Your Ref: N/A  
Our Ref: 17037 Letter 006  
Date: 17<sup>th</sup> July 2019

**Re: Modification to Calderwood Concept Plan - Major Project 09\_0082 MOD 4  
- Public Submission in Response to RTS Documents on Public Exhibition**

**Sketch showing DA0586-2017 Bulk Earthworks Drawings\* compared with the Flood Mitigation Plan in CCP Appendix C11**

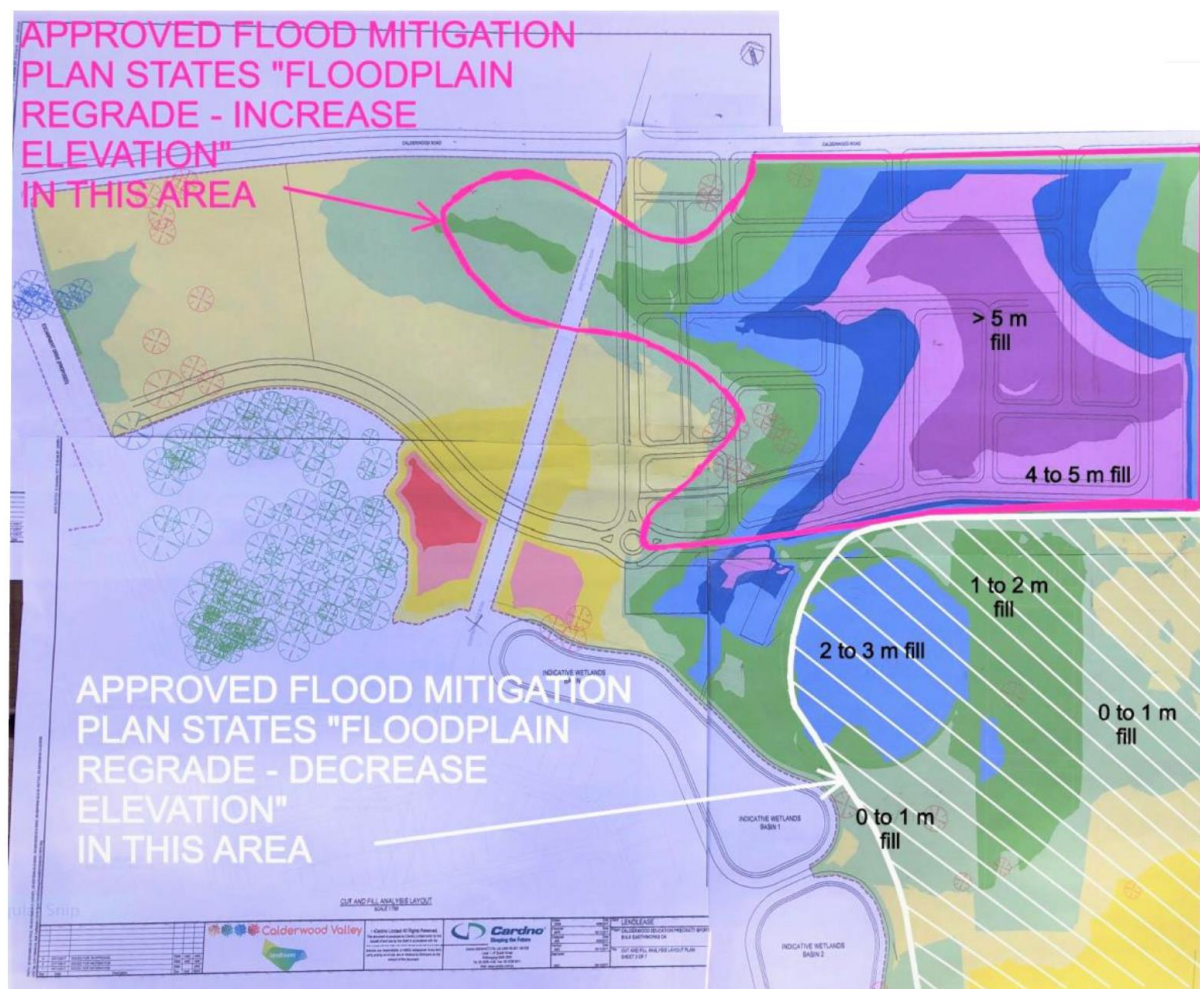
The Wyndham Prince Post Exhibition Report also lacks clarity in response to queries raised on bulk earthworks scenarios used in their flood modelling. They say, *'the cut and fill plan carried out by J. Wyndham Prince is generally consistent with the bulk earthworks plans submitted to SHCC in support of DA0586-2018 which is currently under assessment'*. They purport to offer objective evidence regarding this by stating, *'Nevertheless, a revised cut and fill plan is present in figure 8.10 the Post Exhibition WCFM report which includes locations and depths of the proposed cut and fill'*. Figure 8.10 however doesn't show any cut/fill at the sports ovals.

This issue is however further addressed, in part, through the statement that *'Minor changes on the cut/fill including south of Macquarie Rivulet adjacent to stage 1 have been implemented to facilitate an improved flow management in the corridor which is consistent with the original approval.'* There is no objective evidence however to support the statement that the earthworks changes are minor. As per the sketch below showing the bulk earthworks drawings submitted in support of DA0586-2017 compared with the Flood Mitigation Plan in Appendix C11 of the CCP, the changes to proposed earthworks cannot be described as minor.

1. A corrective version of Figure 8.10 be prepared reflecting the bulk earthworks scheme described on the plans submitted in support of DA0586-2017.
2. A further plan be prepared showing the differences between the corrective version of Figure 8.10 and the approved cut and fill areas on Flood Mitigation Plan at Appendix C11 of the Consolidated Concept Plan.

3. Once the differences are identified it is suggested that either Figure 8.10 be further amended to be consistent with Consolidated Concept Plan Figure C11, or alternatively additional information be submitted by the Applicant justifying the departures from the cut and fill arrangement shown on Consolidated Concept Plan Figure C11. Such justification should include comparative cut/fill volumes, differences in the comparative quantities of topsoil v material suitable for re-use as structural fill generated from the changes, the need for any additional imported fill and the proposed way of dealing with the disposal of any additional quantities of topsoil either on-site or off-site.
